CITY OF ALBUQUERQUE

Re: Villas Las Mananitas Commercial Grading and Drainage Plan Engineer's Stamp date 6-15-09 (H13/D050A)

RE: REVISED GRADING AND DRAINAGE PLAN FOR VILLAS LAS MANANITAS COMMERCIAL (H13/D050A)

Re: Villas Las Mananitas Commercial Grading and Drainage Plan Engineer's Stamp dated 2-20-09 (H13/D050A)

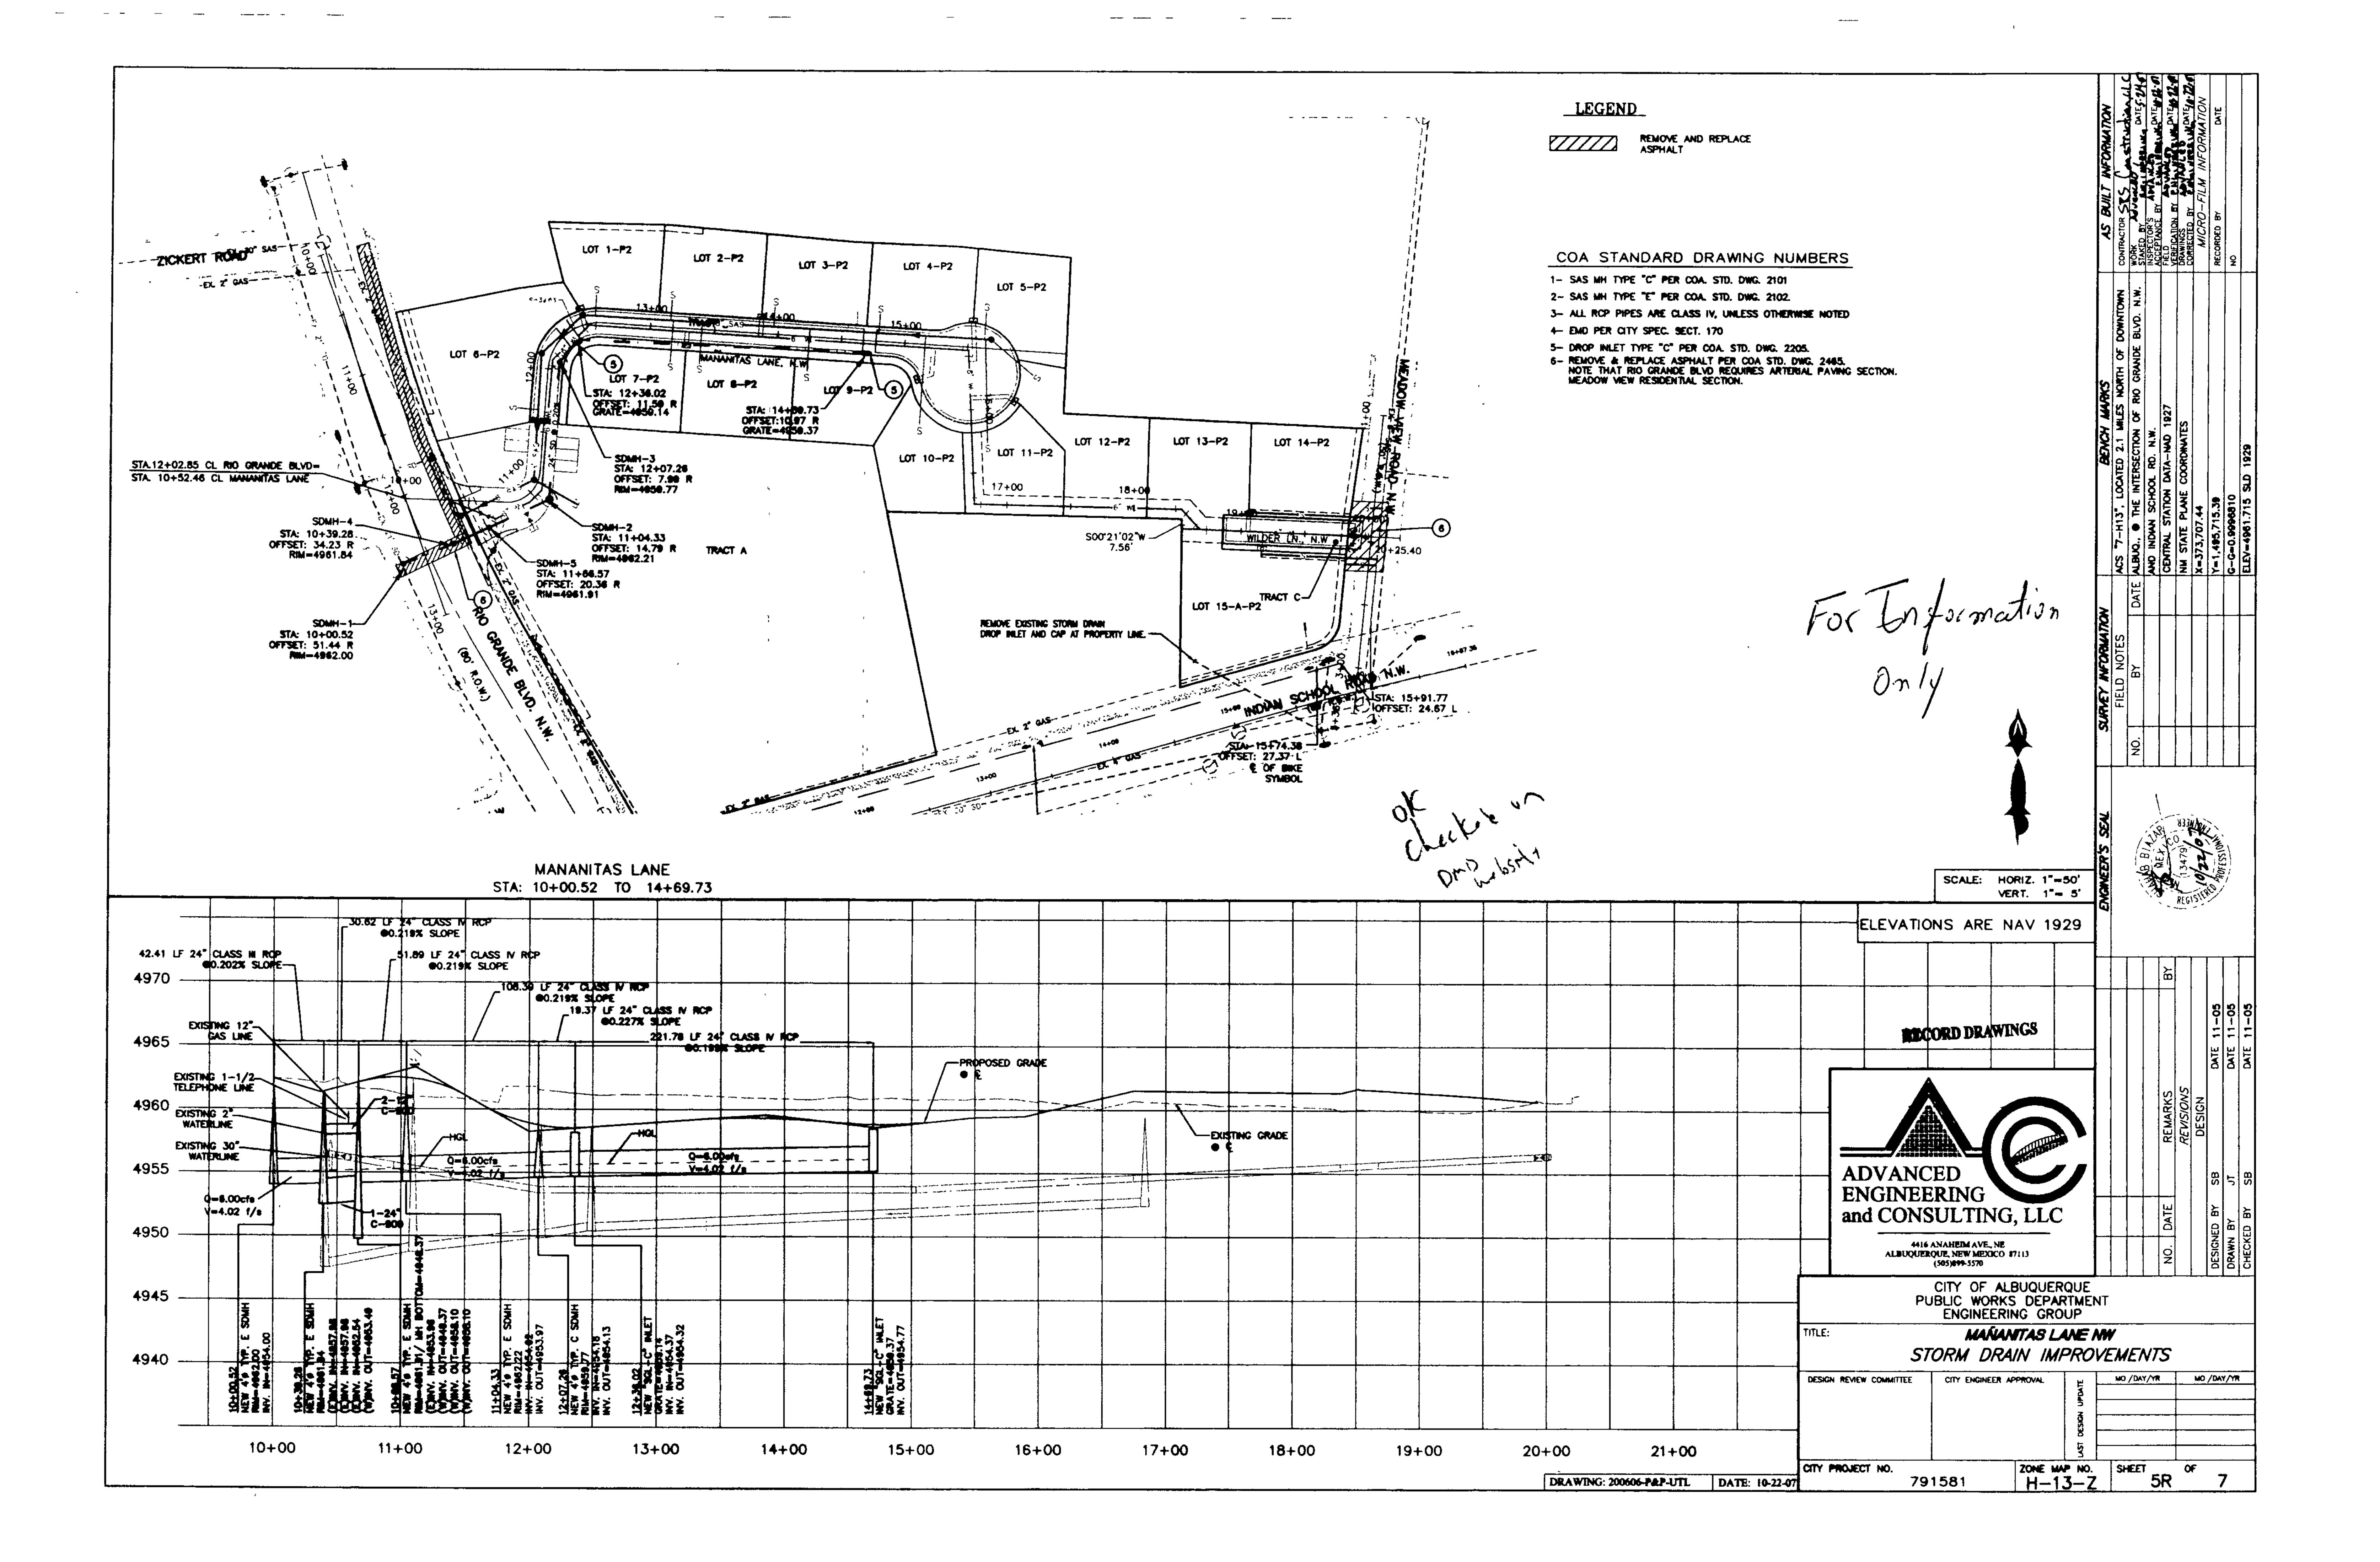
- There is most likely little capacity in the storm drain in Rio Grande Blvd. The runoff from this site should enter the storm drain before the runoff peak in the storm drain. However, in the case where the system backs up, all of the buildings should be elevated. Since it is not possible to elevate the historic building, F.F. 4961.6, the design must provide a means to keep this building from flooding. In addition, more elevation data is required around this building so it is evident which way this area drains.
- Provide elevation data in the entrance (quarter points, at the high point, and to the subdivision entrance) off of Rio Grande Blvd.

Enclosed please find the revised grading plan for buildings Las Mananitas Commercial. The plans were modified to reflect the NGVD 1988. We had re-surveyed the existing building and there are three finished floor elevations. The lowest elevation is 4963.37. The following are the responses to your comments received dated March 2nd, 2009:

- We have added several spot elevation to assure that the runoff around the existing building will drain to the proposed drop inlet on site. There is an small area at the southwest corner of the property (behind the existing building) were the runoff appears to be trapped. Unfortunately the grades around the site (existing street flowlines are higher than the existing finished floor of the building. The only grade lower than the existing finished floor elevation are the existing inlets at the intersection of Indian School and Rio Grande Boulevard with elevation of 4962.71 and 4962.90.
- Additional spot elevations are shown for the existing entrance from Rio Grande Boulevard.
